WORK ORDER NON-CONFORMANCE / UPDATE

Work Order ID 150739

DESIGN CP	DRAWN BY CP	DART	DART AEROSPACE LTD. HARRISBURG, ONTARIO, CANADA
CHECKED #	APPROVED #	DRAWING NO. D3016	REV. A
DATE 01.05.18	TITLE SEAT FRAME ASSEMBLY	SHEET 2 OF 3	SCALE 1:3

DRAWING NO. D3016	TITLE SEAT FRAME ASSEMBLY	REV. A	DART AEROSPACE LTD ENGINEERING ORDER	D.E.O. NO. D3016-A-1	SHEET NO. SHEET 1 OF 1	SCALE NTS
DRAWN <i>1</i>	CHECKED <i>UP</i>	MFG. APPR. <i>RE</i>	APPROVED <i>MAP</i>	DE APPR. <i>11</i>		
DATE 10.01.29	DATE 10.01.29	DATE 10.01.29	DATE 10.01.29	DATE 10.01.29

D3016-11 SADDLE

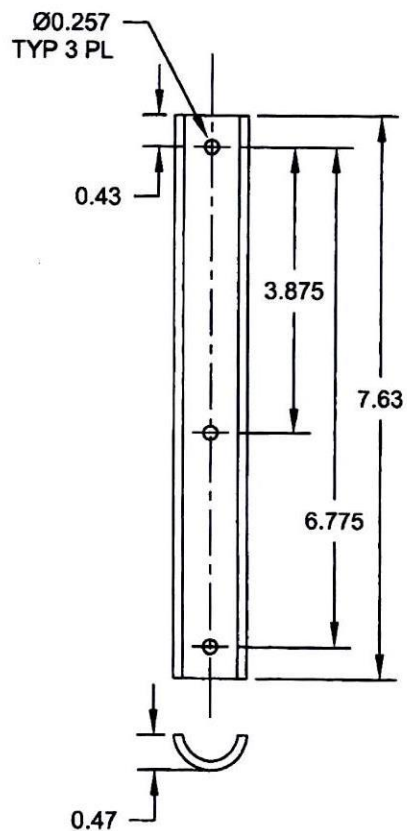
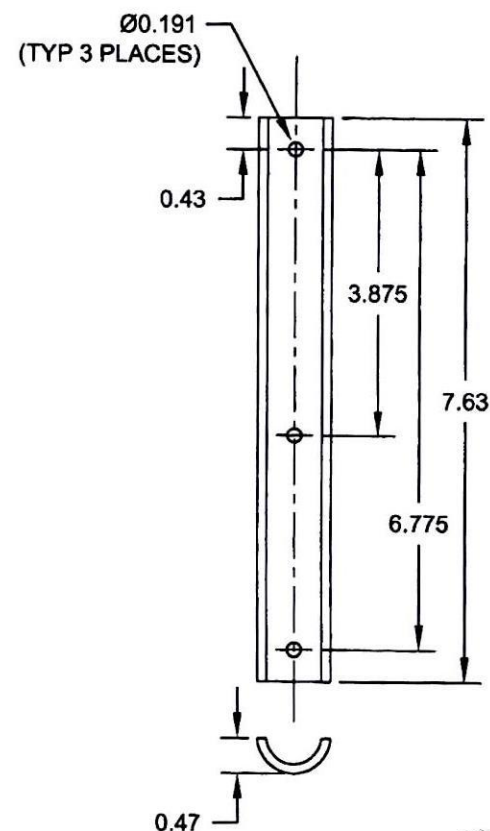
PURPOSE:

TO REVISE D3016-11 SADDLE'S HOLE SIZES

DETAIL D3016-11 SADDLE (SHEET 3): Ø0.257 TYP 3 PL WAS Ø0.191 (TYP 3 PLACES) AS SHOWN:
